ADDENDUM NUMBER 1

1.01 DATE: OCTOBER 11, 2017

1.02 PROJECT: **MIDLANDS TECHNICAL COLLEGE - WADE MARTIN CHILLER REPLACEMENT**

1.03 PROJECT NUMBER: **H59-N975-FW**

sheet title
PARTIAL FIRST FLOOR PLAN
HVAC RENOVATION

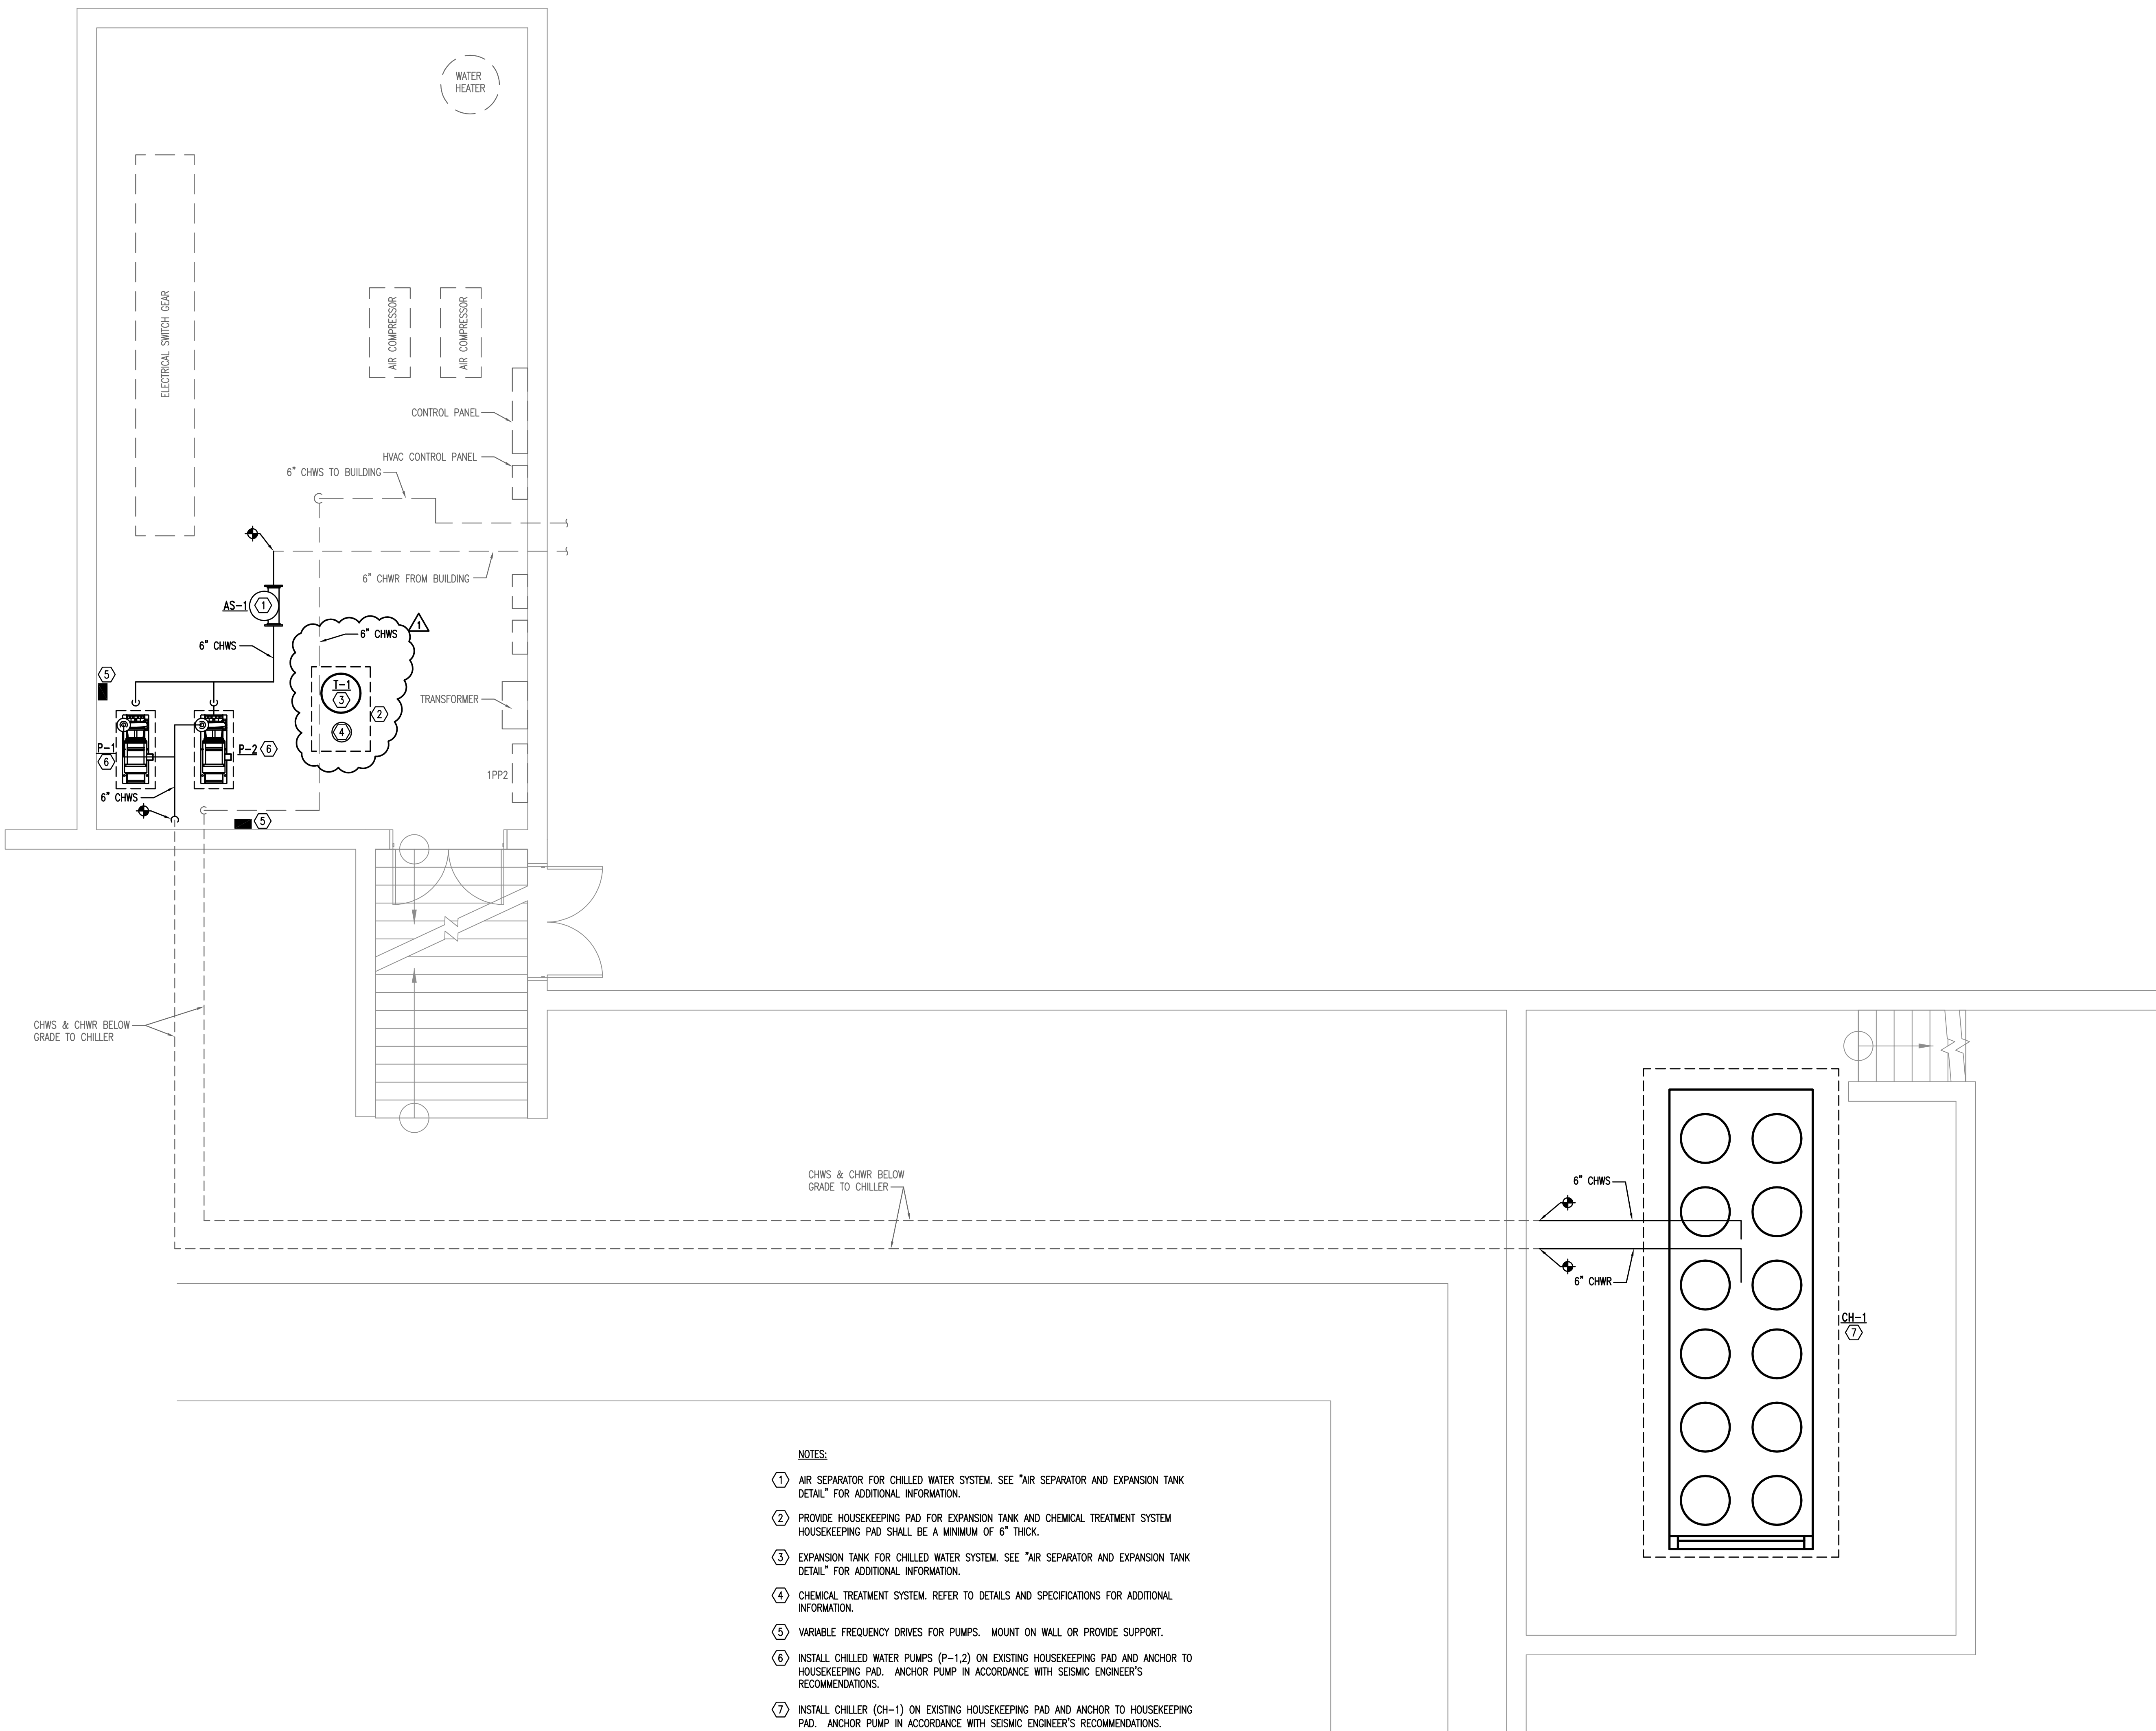
6.01 DRAWING M3.1 - PARTIAL FIRST FLOOR PLAN HVAC RENOVATION

A. Relocate expansion tank (T-1) and chemical treatment system as indicated in the revised drawing.
